COUNCIL ASSESSMENT REPORT

HUNTER AND CENTRAL COAST REGIONAL PLANNING PANEL

PANEL REFERENCE & DA NUMBER	PPSHCC-159 – DA2022-01316 - PAN-280683
PROPOSAL	DA2022-01316 - Stage 1 involving demolition of existing structures and the erection of a mixed use development proposing 136 apartments, retail premises and associated parking, landscaping, services and associated two lot subdivision.
ADDRESS	Lot 1 DP 867617 - 711 Hunter Street Newcastle West
APPLICANT	Urbis Pty Ltd
OWNER	Hunter Street JV CO Pty Ltd
DA LODGEMENT DATE	17/11/2022
APPLICATION TYPE	Development Application
REGIONALLY SIGNIFICANT CRITERIA	Section 2.19(1) and Clause 2 of Schedule 6 of State Environmental Planning Policy (Planning Systems) 2021 declares the proposal regionally significant development as: Development that has a capital investment value of more than \$30 million.
CIV	\$65,382,029.00 (excluding GST)
CLAUSE 4.6 REQUESTS	<ul style="list-style-type: none"> • Cl4.4 – Floor Space Ratio NLEP 2012 • Cl7.4 – Building Separation NLEP 2012

<ul style="list-style-type: none"> • Amended ADG Assessment • Amended Clause 4.6 Variation Statement – FSR • Amended Clause 4.6 Variation Statement – Building Separation • Lift Capa

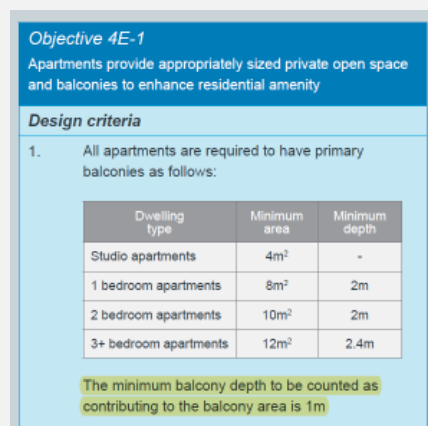
The original assessment of the balconies by CN was undertaken on a 'strict' interpretation of the *Objective 4E-1 Design Criteria 1* (see screenshot below for reference) – only counting areas of the balcony which achieve at least the minimum depth noted in the table as contributing towards the minimum balcony area required.

The ADG balcony criteria, as detailed within the table above, allows for an interpretation where areas of the balcony less than 2m wide, but 1m or greater in width, can still contribute towards the primary balcony area. Based on this interpretation it means that all 23 apartments identified as 'non-complying' in stage 1 would actually comply, and for 65 out of the 67 apartments identified as 'non-complying' in stage 2 would actually comply, as follows:-

- 132 out of 132 apartments in stage 1 comply, or 100%.
- 116 out of 118 apartments in stage 2 comply, or 98.2%. The non-complying apartments are identified below:

<ul style="list-style-type: none"> Apartment 2.24.01 – the maximum balcony width at any point is 2m. A minimum width of 2.4m is required for 3 bedroom apartments. Apartment 2.24.03 – the maximum balcony width at any point is 2.2m. A minimum width of 2.4m is required for 3 bedroom apartments. 248 out of 250 total apartments comply, or 99.2% <p>The ADG is inherently a guideline and consideration needs to be given to the overall outcomes achieved in this instance. It is considered that the non-compliances by the two apartments is not substantial and will still be fit for purpose in this instance notwithstanding the small variation to the balcony widths proposed.</p>	
--	--	--

Figure 1 - Movable all weather protection of floor refuge

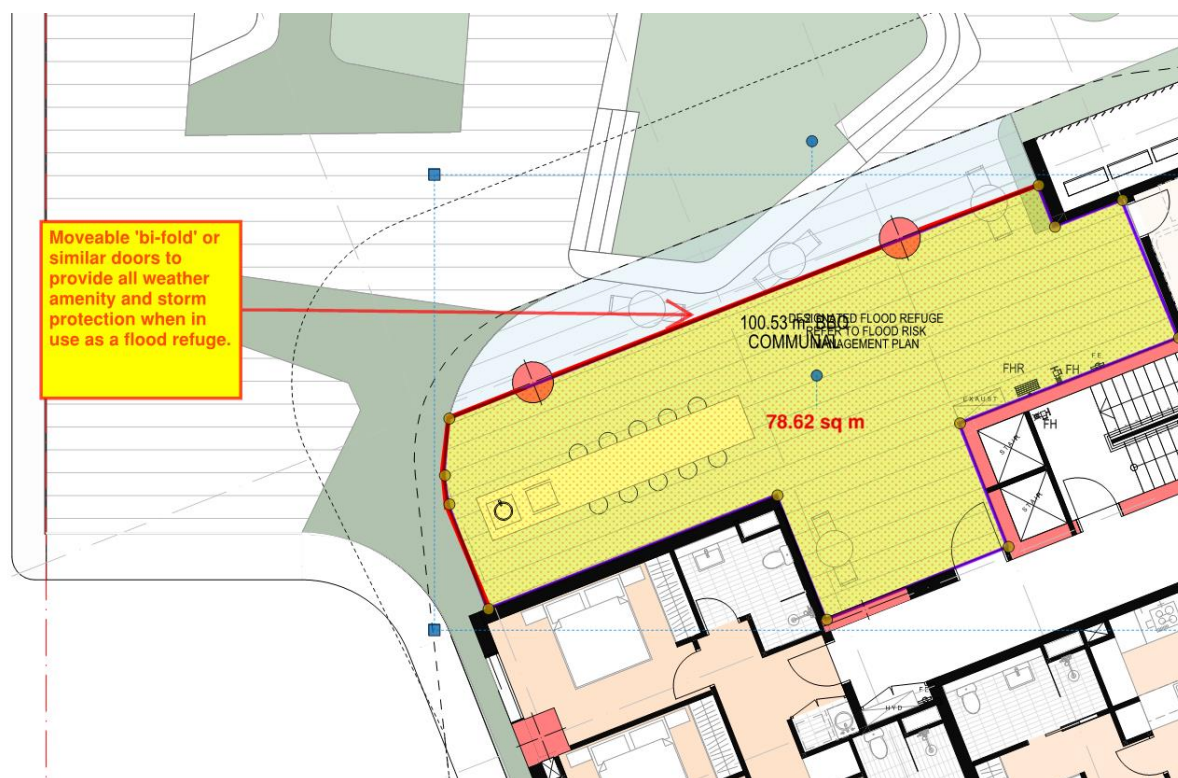
The proposed flood refuge area is proposed to utilise the communal room area on the fifth floor podium level (see **Figure 1** below). The flood refuge as submitted is not fully enclosed and would not be sufficiently weather proof in a storm event. To address this issue, a condition of consent has been recommended to address the all weather protection (which is detailed in the assessment below under Flooding).

In terms of GFA, and the proposed cl4.6 variation request, the imposed condition would result in additional GFA (i.e. 78.62 m²) as it allows the space to be enclosed with walls, although movable, as it would meet the definition of GFA. The applicants have not had an opportunity to address this within their submitted cl4.6 request as it is the result of a recommended condition. Notwithstanding this, the effect of this area technically becoming GFA/FSR is considered to be reasonable. The enclosing of this area on a temporary basis would not change the intensity of use of the area generally, occupies a space within the design which otherwise already exists, being an undercroft area which recessed within the design, and does not protrude as an additional element or similar. The proposal creates no unreasonable additional amenity or privacy impacts considering the communal area's position within level five and its intended use.

The main issue that arises is the architectural appearance of the proposed "bi-fold doors or similar". This is addressed by requiring that the final amended design be approved by CN's UDRP.

In terms of the additional FSR, the increased GFA proposed by including the communal room area on this basis would constitute a total variation of 288.85 m² (i.e. 14093.85 m² for Stage1) and a total percentage variation of 2.09% (i.e. the communal room results in an additional 0.57% variation of itself).

Figure 2 - Movable all weather protection of floor refuge

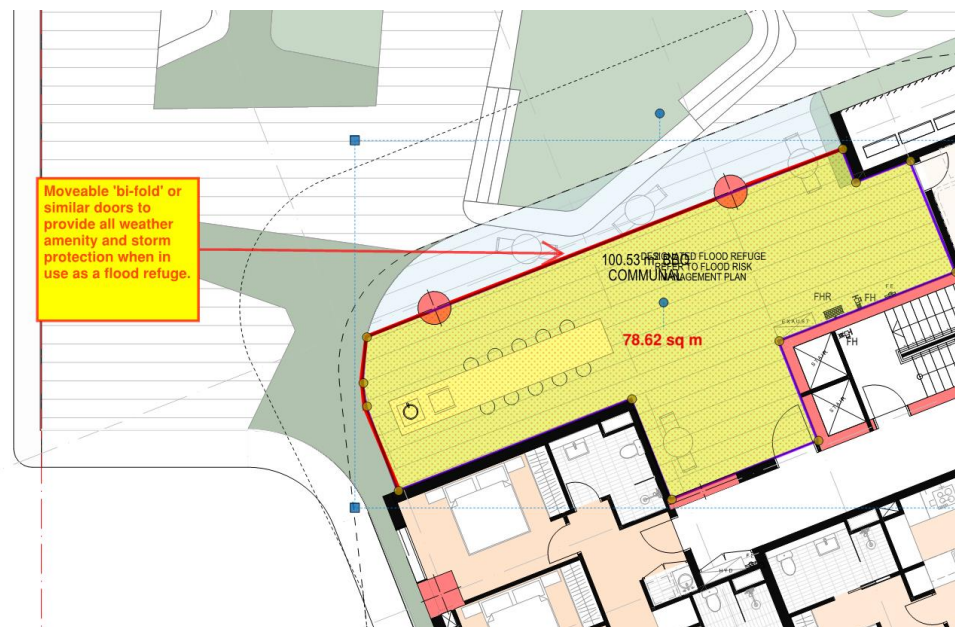
HCCRPP's deferral of the application raised 'arrangements for shelter in place'.

It is necessary that reciprocal rights of access be provided to all common areas including the podium and required flood refuge (which is addressed by conditions of consent included at **Attachment A**).

The proposed flood refuge is considered to have sufficient area for its purpose as it only needs to be available for staff and customers of the ground floor retail premises. The flood refuge is not fully weather enclosed as proposed. It is considered that when the use of the flood refuge is necessary, this would typically be a significant storm event. To address this issue it is recommended that a condition of consent be imposed (as included at **Attachment A**) that the area be provided with 'bi-fold' style doors or similar that have a high architectural quality (see **Figure 2** below) such that the area could be enclosed on a temporary basis. This would additionally allow the area to be enclosed to provide all weather amenity for the future residents of the development.

Overall, the proposed flood refuge is considered to be acceptable subject to conditions of consent.
